January 12, 2010

In Reply Refer To: HSSD/B-201

Name of device: VulcanTM Gate
Type of device: Longitudinal Barrier

Testing Level: NCHRP Report 350 TL-2, TL-3 and TL-4

Figure 1. Summary of Results - Vulcan Gate Test 01-8430-010

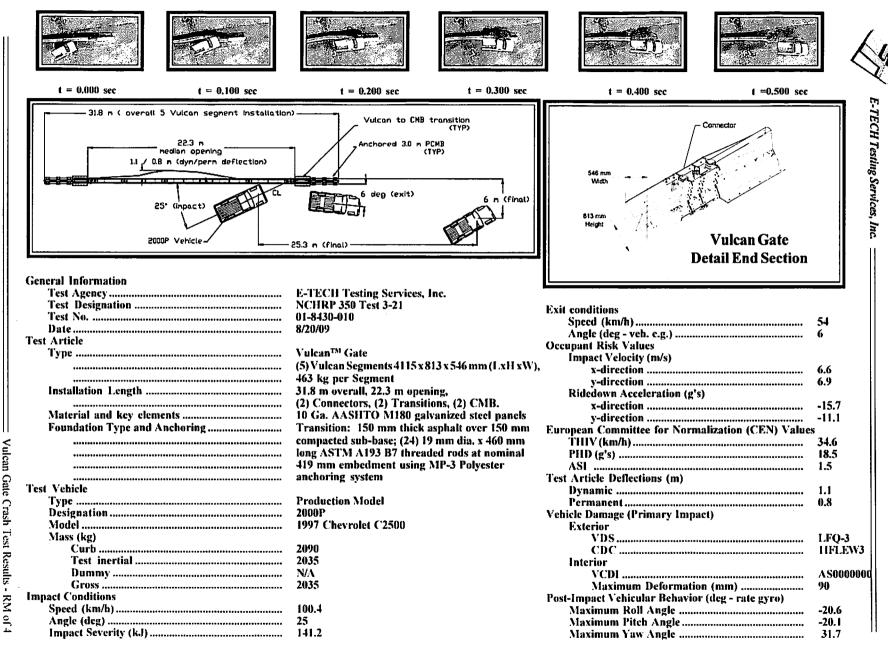
For this test, five freestanding Vulcan segments were pinned together and the upstream and downstream ends were pinned to unanchored Hinge/Connectors which were pinned to anchored Vulcan-to-PCMB Transition segments to provide longitudinal tension. The impact point was the first Vulcan segment ahead of the new Hinge/Connector.

We concur with your request that the VulcanTM Gate Longitudinal Barrier be granted equivalence to existing successfully crash tested systems meeting TL-2, TL-3, and TL-4 conditions as per NCHRP Report 350 and will be considered acceptable for use on the NHS system when requested by a highway agency. In addition, we concur that the submitted successful crash test results support use of this design with any number of Vulcan segments to configure a VulcanTM Gate Longitudinal Barrier. For further information on the crash test, the Test Data Summary Sheet is included with this correspondence.
